SELF-STORAGE AT CITADEL  
SITE PLAN WITH CONDITIONAL USE

SELF-STORAGE AT CITADEL  
LOT 1, BLOCK 4  
CITADEL ON COLFAX SUBDIVISION FILING NO. 1

14909 E. 14TH PLACE  
AURORA, CO

LANDSCAPE NON-STREET BUFFER TABLE

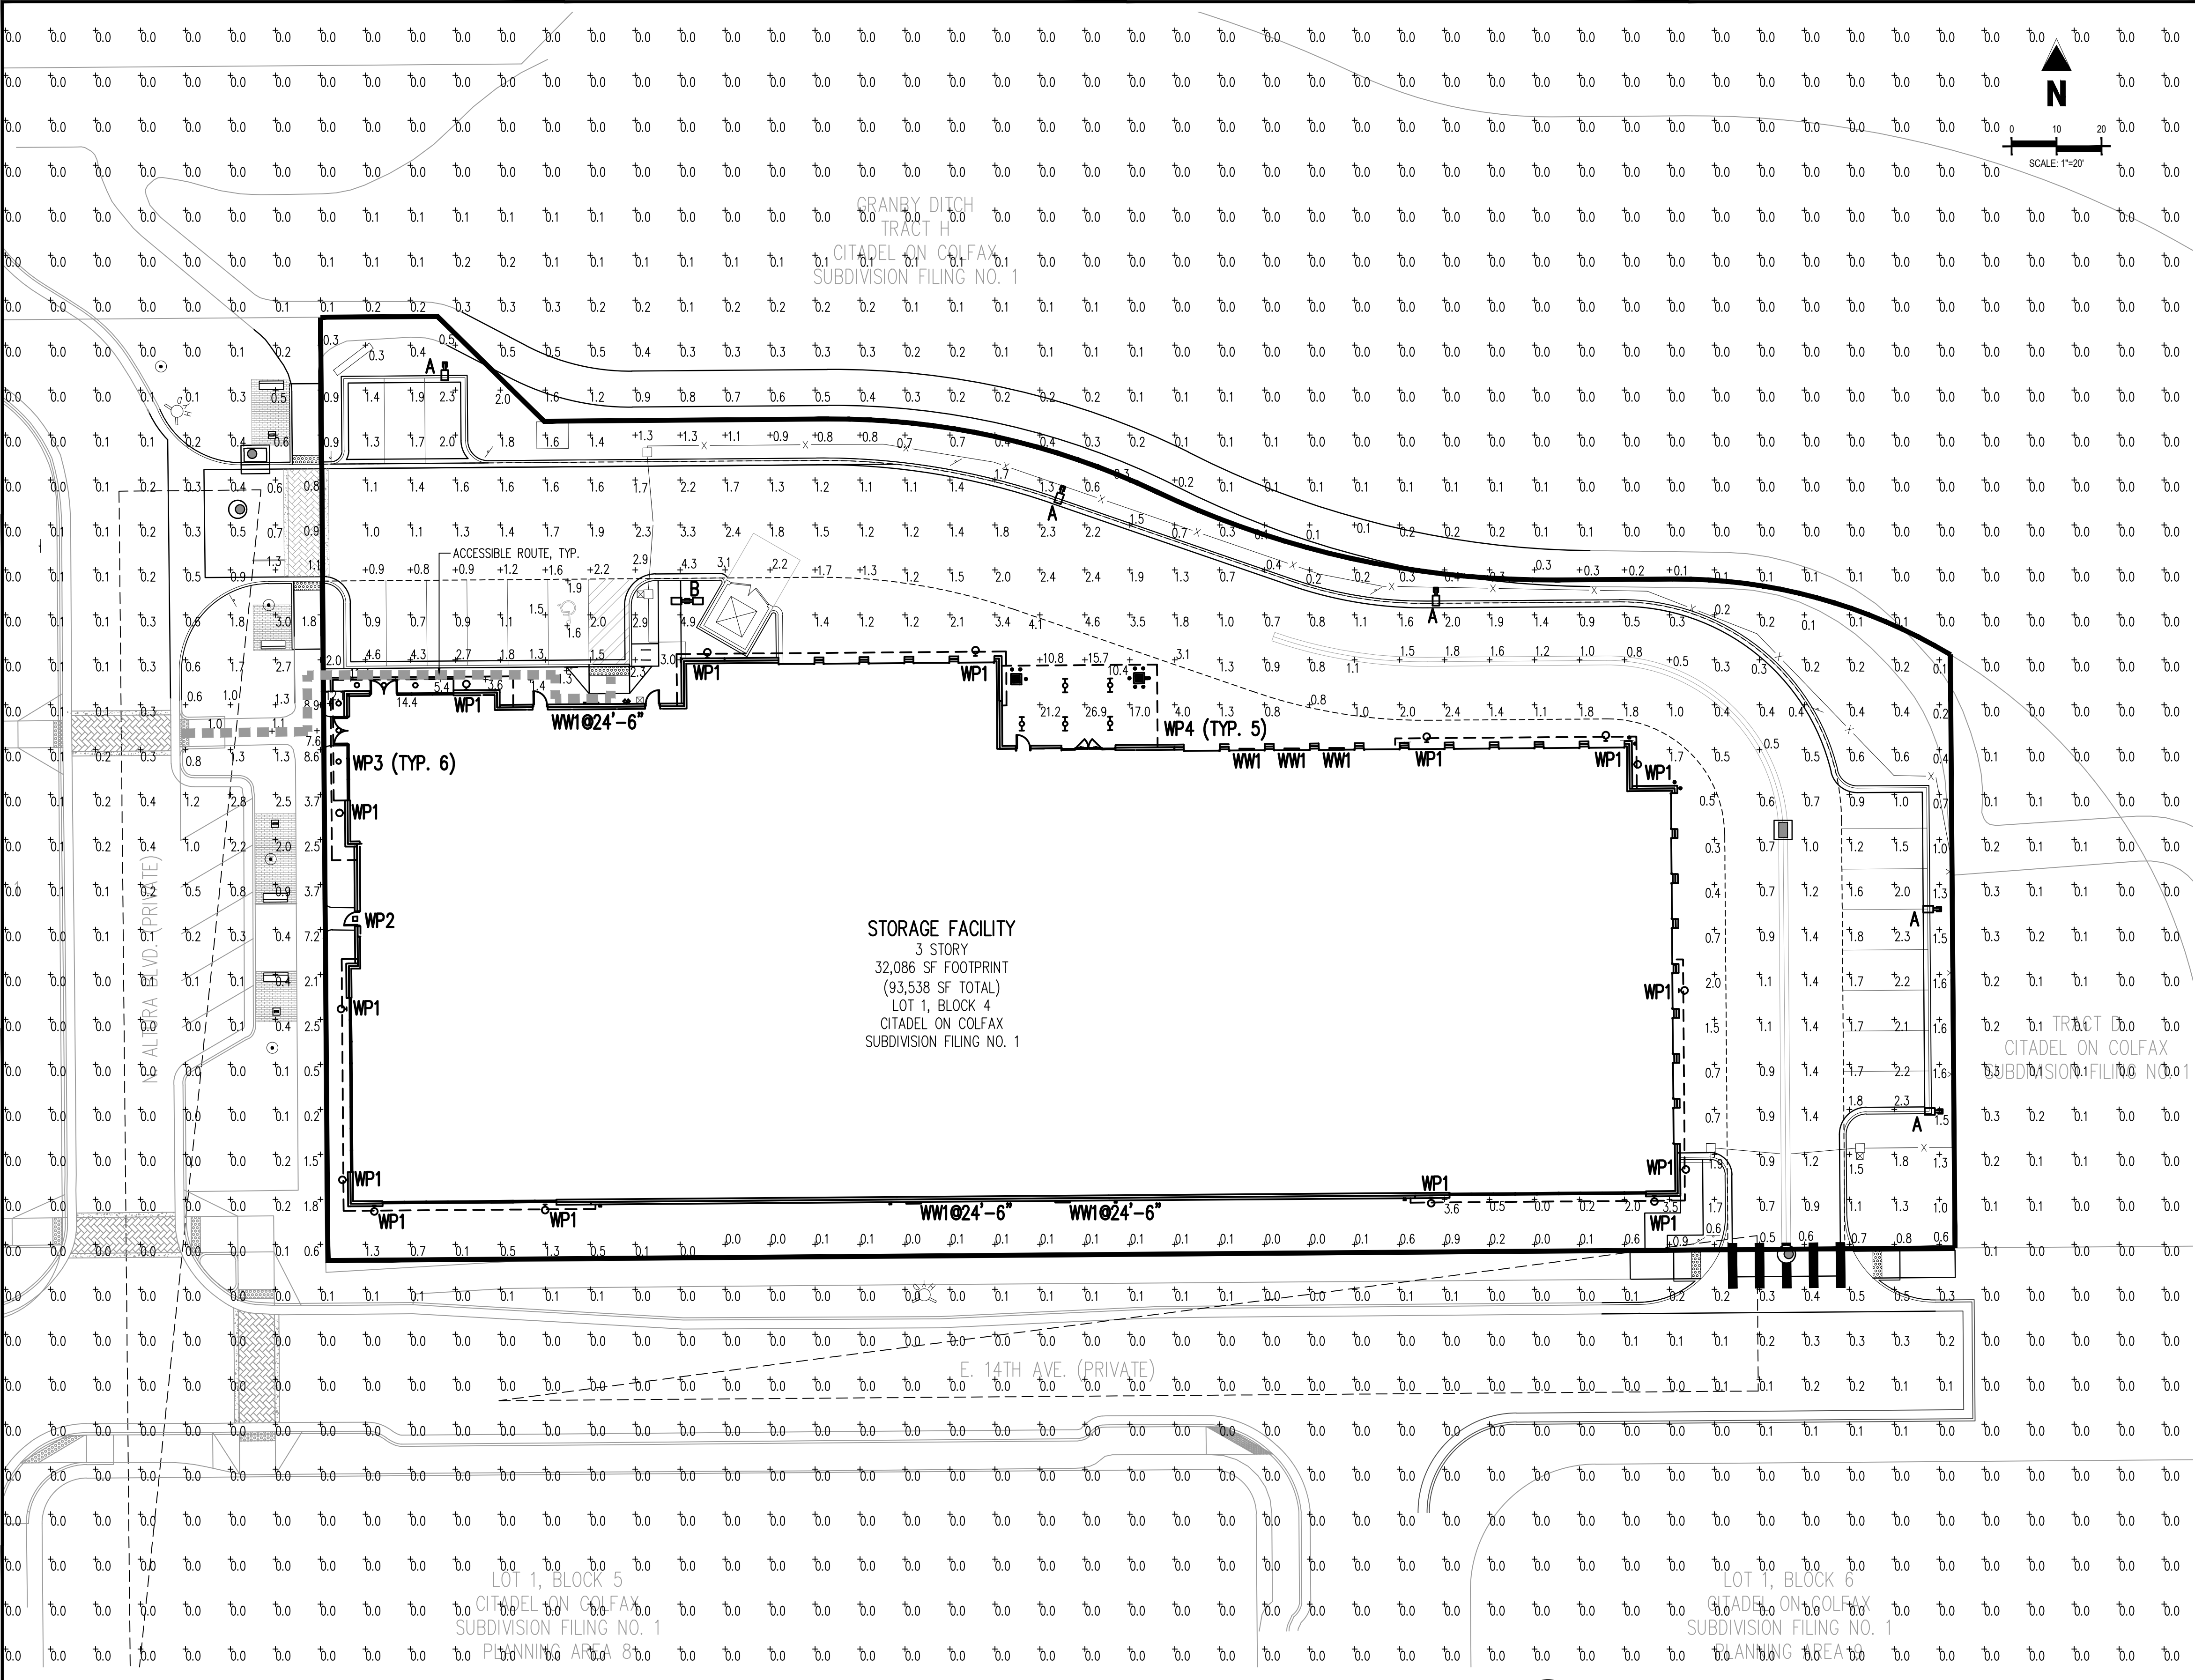
As mentioned in the previous set of review comments, shrubs may not be substituted for trees in the buffer unless there is an encumbrance. See UDO for what constitutes an encumbrance. Perennials can not be used to meet buffer requirements and grasses may only account for 20% and should be 5 gallon.

Tree quantities should be provided unless there has been an encumbrance demonstrated.

There are not 1115 shrubs, typol, There are approximately 80 shrubs. Does not meet code.
